DRAFT LAKE TANEYCOMO TMDL

COMMENTS from Southwestern Power Association ONLY

Public Notice
July 30 – Sept. 13, 2010

Lake Taneycomo
WBID # 7314

Source: MoDNR, 2009 – Lake Taneycomo 2010 303(d) Assessment Worksheet

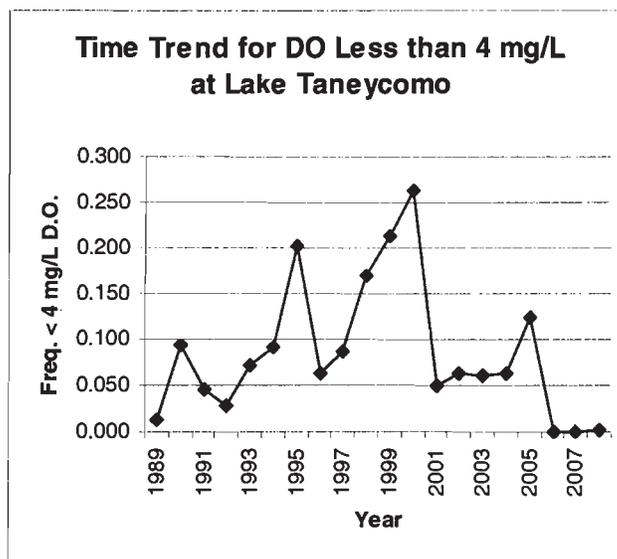
Since 1998, the daily minimum dissolved oxygen has failed to meet the state dissolved oxygen standard 31.7 percent of the time. Over the last seven years, the exceedance rate is somewhat better, 26.8 percent. Since 2006, operations at Table Rock Dam have been much more effective in keeping minimum dissolved oxygen levels above 4 mg/L. Dissolved oxygen frequency of exceedance and time trend plots have been included below for your reference. These plots illustrate that, while applicable water quality standards are not currently being met, conditions in Lake Taneycomo are improving as U.S. Army Corps of Engineers and Southwestern Power Administration implement technologies and practices to improve dissolved oxygen in Table Rock Dam's tailwater.

Because dissolved oxygen conditions and the cold water fishery use are being met much of the year (especially outside the low DO season), it is premature to discuss changes to the designated uses and/or water quality standards for Lake Taneycomo. Especially considering water quality conditions have improved during the low dissolved oxygen season over time due to structural and operational modifications at the dam. TMDLs are developed to address applicable water quality standards as found in existing state and federal rule. Therefore, modification of the cold-water fishery designated use and applicable criterion will not be included in the TMDL as a regulatory option. However, should Southwestern wish to discuss this topic further, the Department would be willing to review any relevant data and information during a future triennial review of Missouri's Water Quality Standards. Any information used to support a redesignation of beneficial uses would need to demonstrate that a lower aquatic life protection use or DO criterion would not have negative effects (i.e., impair) the existing cold-water fishery designated use.

Examples of Summer Hypolimnetic Dissolved Oxygen Levels in Three Oligotrophic Missouri Reservoirs and Comparison to Table Rock Lake

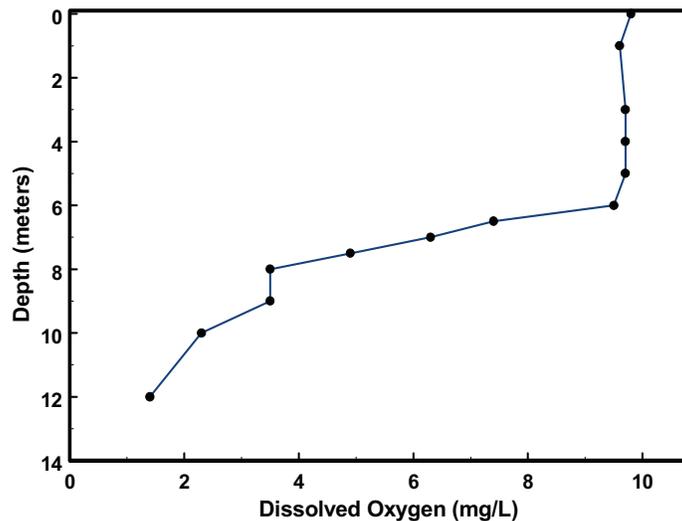
Here are a few graphs showing that Missouri's oligotrophic reservoirs have low hypolimnetic DO during the summer, along with a small write-up explaining how hydrology makes our reservoirs different from those oligotrophic natural lakes that support lake trout.

Council Bluff Lake [440-acre reservoir in Iron County, Missouri; the largest lake in the Mark Twain National Forest]

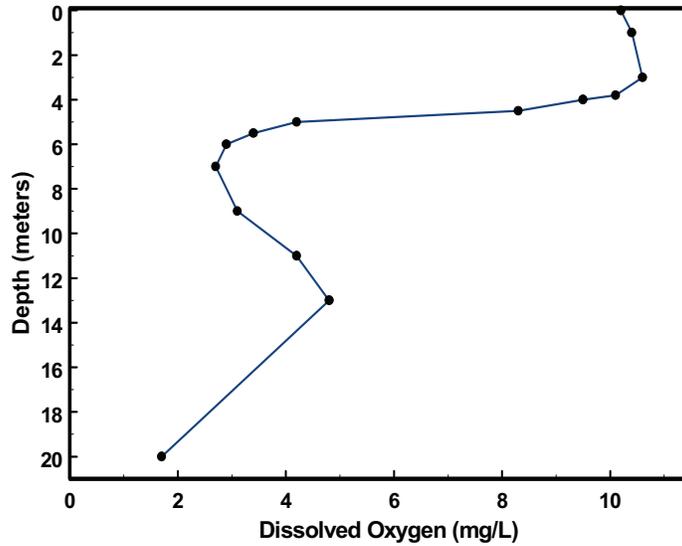
The second figure shows the Council Bluff Lake DO profile from 27 July, 2009. This lake had an average phosphorus value of 8 $\mu\text{g/L}$ and average chlorophyll concentration of 2.5 $\mu\text{g/L}$ during the summer of 2009. Dissolved oxygen levels were <6 mg/L between 5 and 20 meters, representing a full 75% of the water column having insufficient DO levels to support a cold water fishery.

Nehai Tonkayea [250-acre reservoir on a tributary of the Mussel Fork River, Chariton County, Missouri]

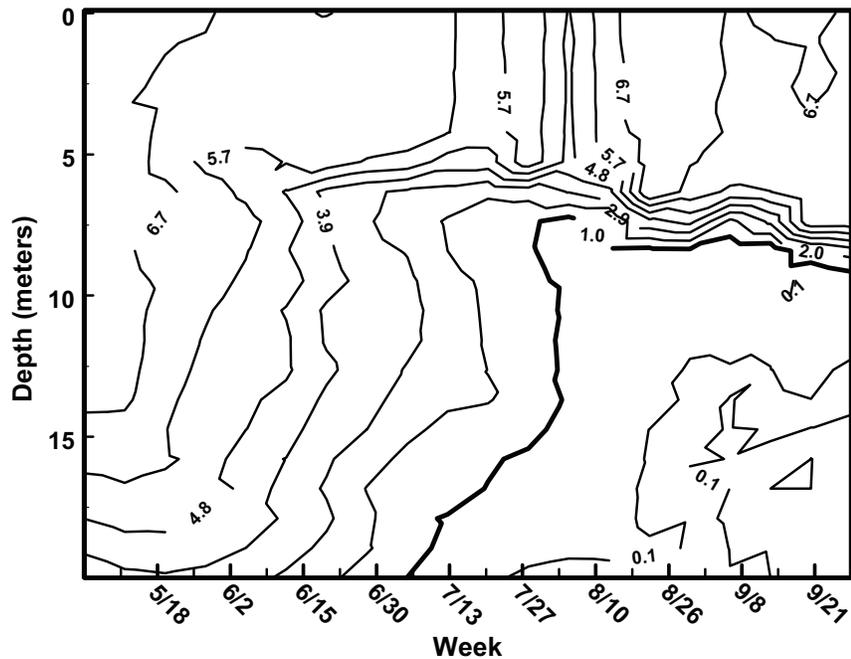
Dissolved oxygen profile data was collected on Nehai Tonkayea Lake on a weekly basis in 2004, with the months of May-September being represented in the third figure. Dissolved oxygen levels near the bottom of the lake dip below 1.0 mg/L in early July, with the whole of the hypolimnion being <1.0 mg/L by early August. This lake had an average total chlorophyll value of 1.9 $\mu\text{g/L}$ in 2004 (n=49), a value that qualifies the lake as oligotrophic. Phosphorus averaged 9 $\mu\text{g/L}$ during 2004; again a level that would lead to an oligotrophic classification.
